PUBLIC WORKS
PLAN REVIEW NOTICE
Phone 305-673-7080 Fax 305-673-7028

Project No.	CHA7009
Scale	AS NOTED
Drawn	DF
Checked	JS/DR
Date	03.30.11
Drawing Title	COVER
Drawing No.	T1.0

DWGS ISSUED					
		PERMIT SET 01-18-2013	1 PLAN REVIEW COMMENTS 03-11-2013	2 PLAN REVIEW COMMENTS 03-25-2013	3 PLAN REVIEW COMMENTS 04-22-2013		
ARCHITECTURAL DRAWINGS							
A0.0	COVER SHEET	●	●	●	●		
A0.1	GENERAL NOTES, CONSTRUCTION TYPES	●					
A1.1	PARTIAL FLOOR PLANS, PARTIAL REFLECTED CEILING PLANS	●	●				
A1.2	PARTIAL FLOOR PLANS, DOOR SCHEDULE	●		●			
A2.1	SECTIONS,DETAILS	●		●	●		
A5.1	ELEVATIONS, TELLER LINE SECTIONS	●		●	●		
CONSULTANT DRAWINGS							
E100	ELECTRICAL FLOOR PLAN	●	●

PARTIAL FURNITURE PLAN - NEW | SCALE 1/4"=1'-0" | 2

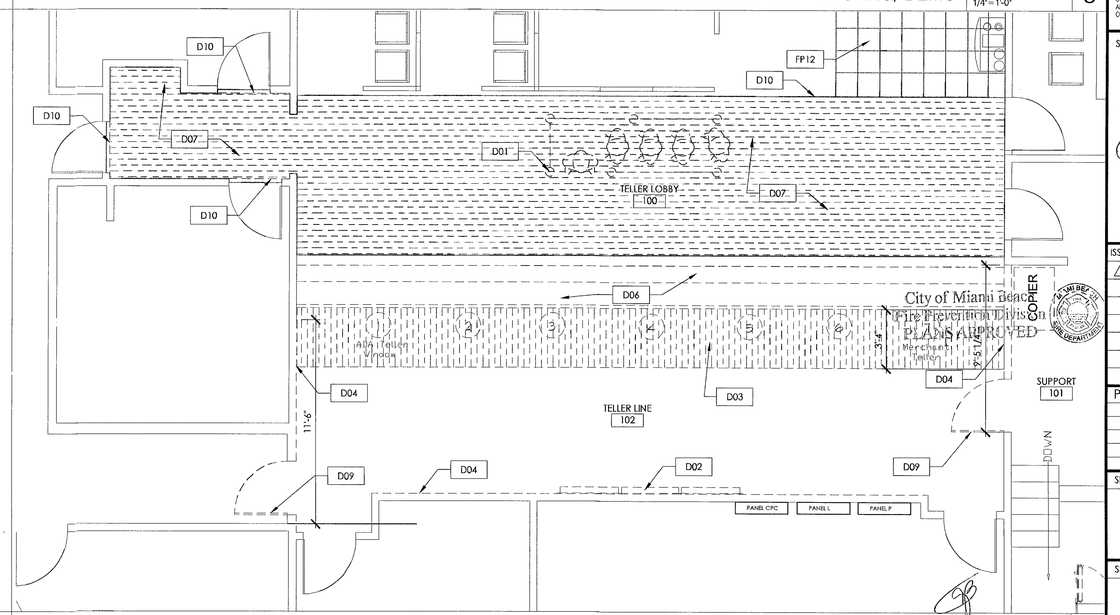
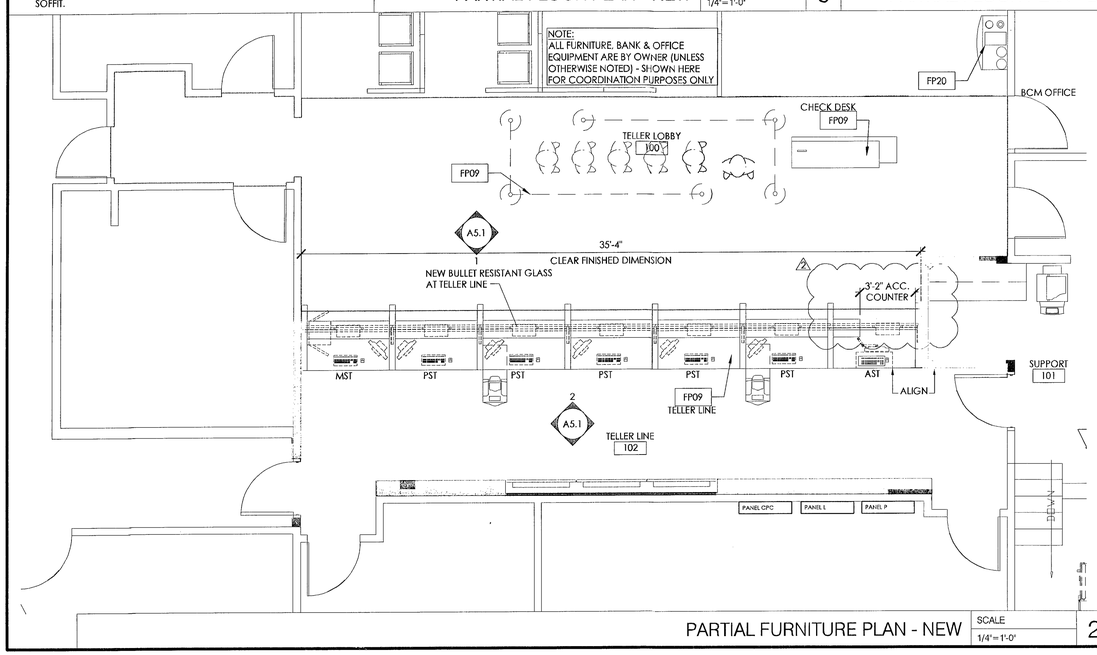
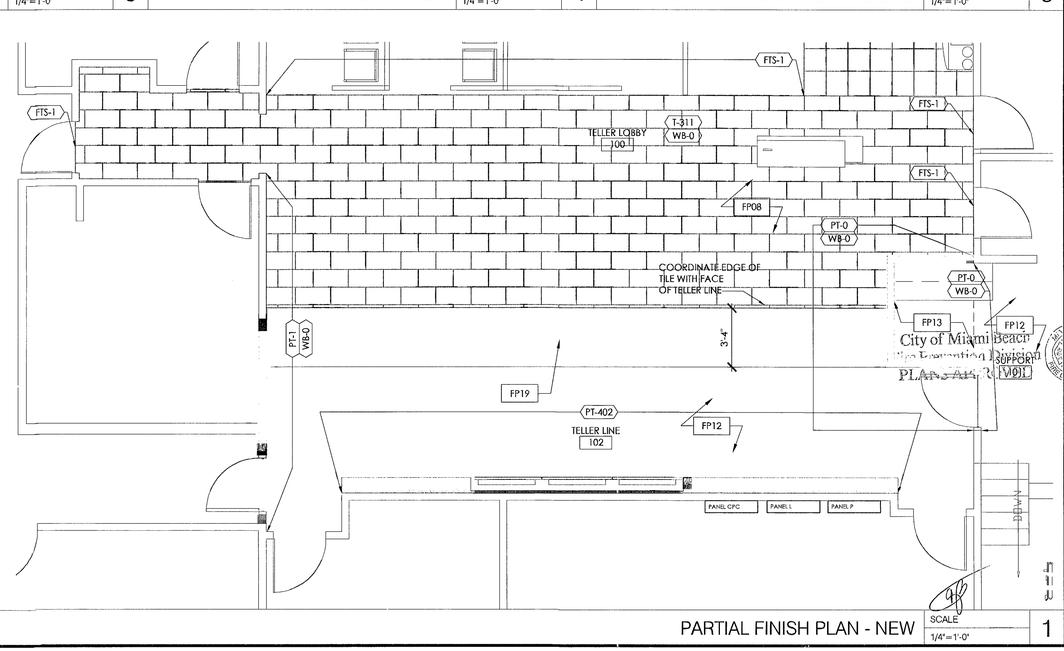
6. **Sheet A1.2: Comfort zones: Provide 36" accessible furniture clearance and provide carpet requirements to comply with FAC §302.2.**
   RESPONSE: Please refer to attached revised sheets A0.0 & A1.2 for accessible clearance and carpet requirements.

7. **Plan 2/A1.2: Check desk FP09: Provide check writing desk accessible details to comply with FAC §904.3.3.** 28-34 HIGH
   RESPONSE: Please refer to attached revised sheet A5.1, detail 9, for accessibility assessment of existing check desk to be relocated.

SHEET NUMBER
A2.1

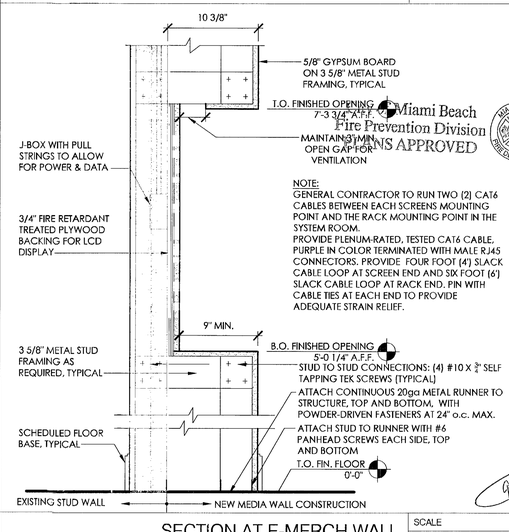
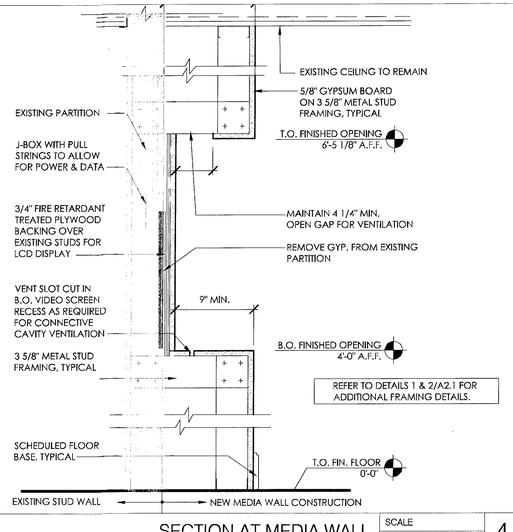
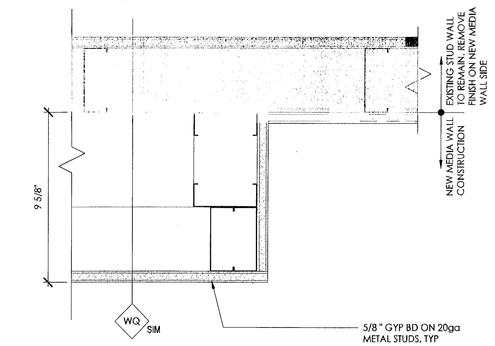
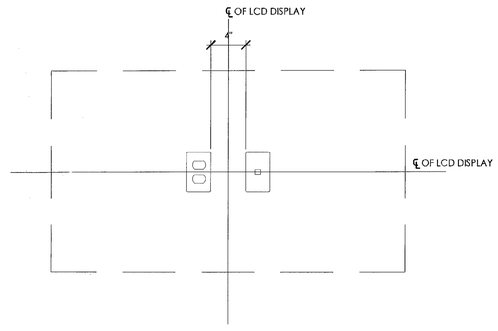
3. **Sheet A2.1 and A5.1: Sections: Provide all framing construction details for review.**
   RESPONSE: Please refer to wall types on sheet A0.1 and attached revised details on sheet A2.1 for requested information. ~~STUD SPACING~~ ? PROVIDE STUD SPACING

4. **Sheet A2.1: Fabric panel details: Provide documentation, testing results to verify compliance with FBC §803.5 and §803.6.**
   RESPONSE: Please refer to attached NFPA 260 Cover Fabric Test Report, as produced by The Govmark Organization, Inc., Farmingdale NY. FBC REQUIRES TESTING PER NFPA 286

SECTIONS AT TELLER LINE | SCALE 3/4" = 1'-0" | 5

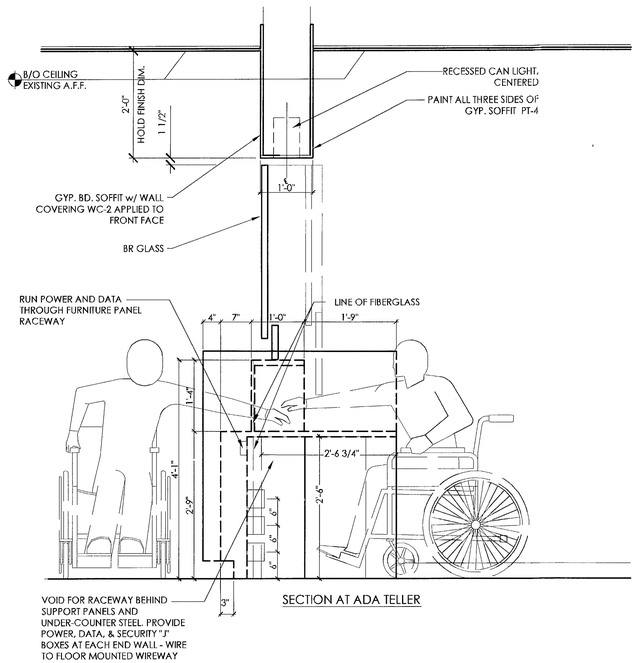
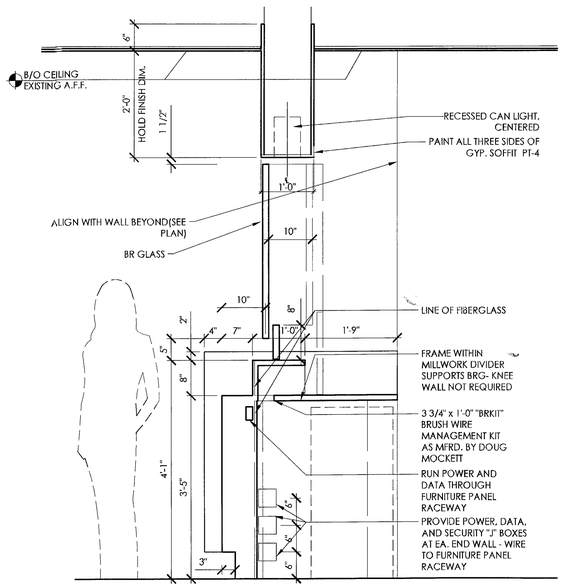
10. **Section 5/A5.1: Provide bottom of counter knee clearance dimension, 27" minimum, per FAC §306.3.**
    RESPONSE: Please refer to attached revised sheet A5.1, detail 5, for requested information.

11. **Section 5/A5.1: Provide 25" maximum reach dimension, suggest reduce 1'-9" dimension to 1'-1" to comply with FAC §308.2.**

ELEVATION AT FRONT OF TELLER LINE | SCALE 1/4"= 1'-0" | 1

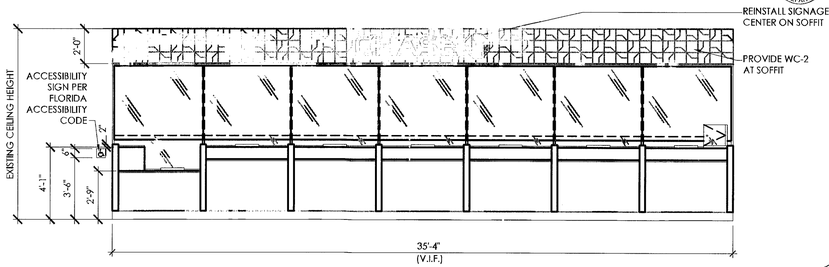
8. **Elevation 1/A5.1: Provide accessibility sign to comply with FAC §216.**
   RESPONSE: Please refer to attached revised sheet A5.1, detail 1, for requested detail.

9. **Elevation 1/A5.1: Provide length of accessible teller counter, 36" minimum, to comply with FAC §904.4.**
   RESPONSE: Please refer to attached revised sheet A1.2, detail 2 for requested information.

FLOOR PLAN – POWER/SYSTEMS
SCALE: 1/8"=1'-0"

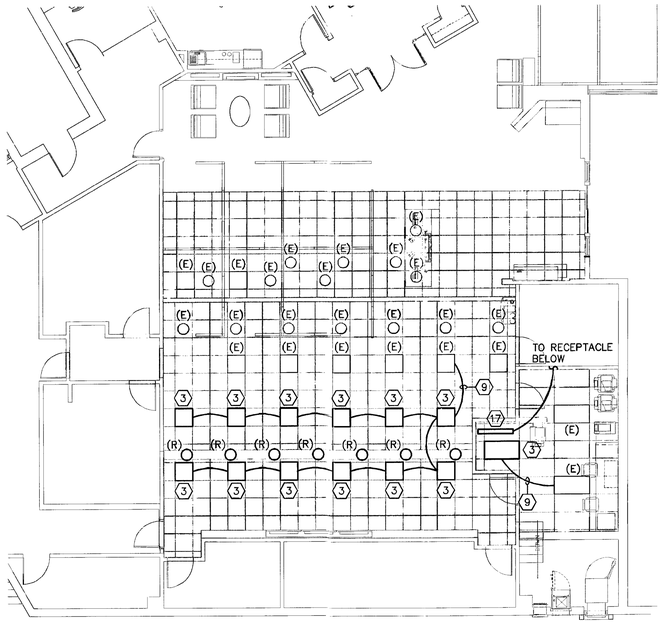
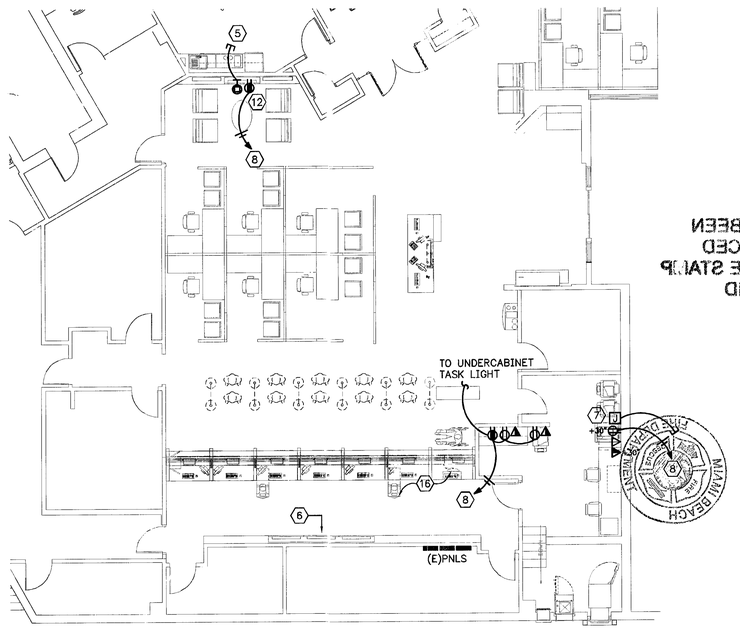
8. **Label all areas sheet e100: 1. show location of emergency lights and exit signs, clarify if these items have battery backup rated for 90 min note once the architect/engineer answers the comments additional comments may follow.**

RESPONSE: Please refer to the attached revised sheets A1.1 (reflected ceiling plan) and E100 for locations of emergency lights within the area of work. Areas have been labeled on sheet E100.
